OFFICIAL COORDINATION REQUEST FOR NON-ROUTINE OPERATIONS AND MAINTENANCE

COORDINATION TITLE- 19TDA07 Lamprey pot trap hoist installation in the East Fish Ladder

PROJECT- The Dalles Dam

Figure 2. Proposed lamprey trap hoist. The I-beams, counter weight guides, and rope to be installed are framed in the red box and located on the south fishway wall.

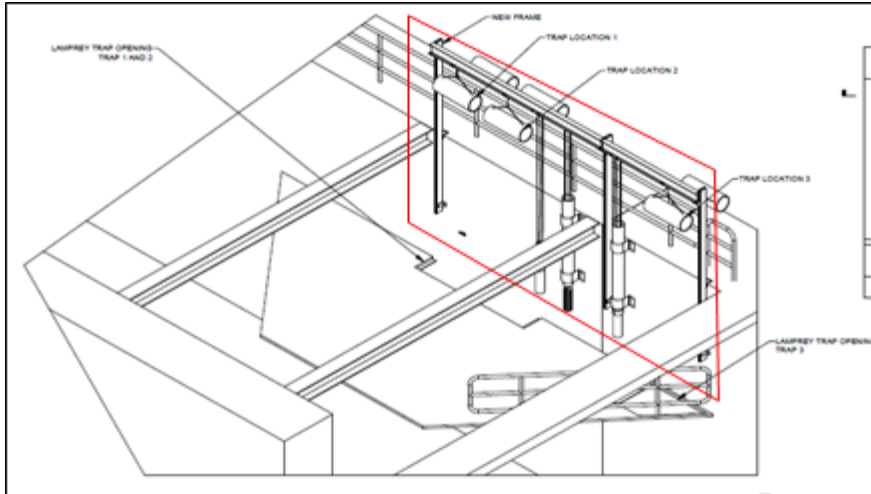
There is no time specified for the work to be conducted. Could it be done during nighttime hours when ladder use is lower? Could it even be delayed until after the passage season?

Drilling will be the noisiest part. Looks to be 8 concrete anchors.
Drilling is about a minute per hole. We could do it mid day to avoid
the morning rush hour of fish. We can monitor the install to keep other
noise to the minimum. And we can put down a mat to catch concrete dust.
Anecdotal info; We have done noisy work here similar to this in the
past. Fish in the downstream pool didn't seem to obviously react to it.
Not to say it may have slowed them down.

We can probably delay the installation but the hope was to get it
installed for this year's lamprey trapping season. Installation at
night is probably not possible due to increased cost and limited
lamprey dollars.

To be clear this work is only going to occur above the water line and
upstream of the picket leads with hand tools. So it won't be directly
above areas where fish are passing. This is the location where the
tribes deploy pot traps starting in late May to mid-June. The actual
construction of the hoist frame will only be 1 day of work. The second
day is just to run rope and place pulleys.

From the May FPOM minutes: **19TDA07 MOC Lamprey hoist EFL installation** – Lorz
suggested doing the work later in the day. There are about 10 bolts to drill into the wall which
will take about 30 mins. **FPOM recommended doing the work later in the day and concurred
with this action.**

Just prior to install the project engineer came up with a modification that would address both hoisting traps onto walkway and hoisting lamprey holding tank up to transport truck. This modification required no added materials or cost. Six holes were drilled at the original locations, 8 more holes were drilled further down the deck about 30' from the fishway exit. Overall the plan was simplified and solved the entire lamprey trap hoist issue. It also improved the transport conditions for lamprey by keeping them in water during more of the process.
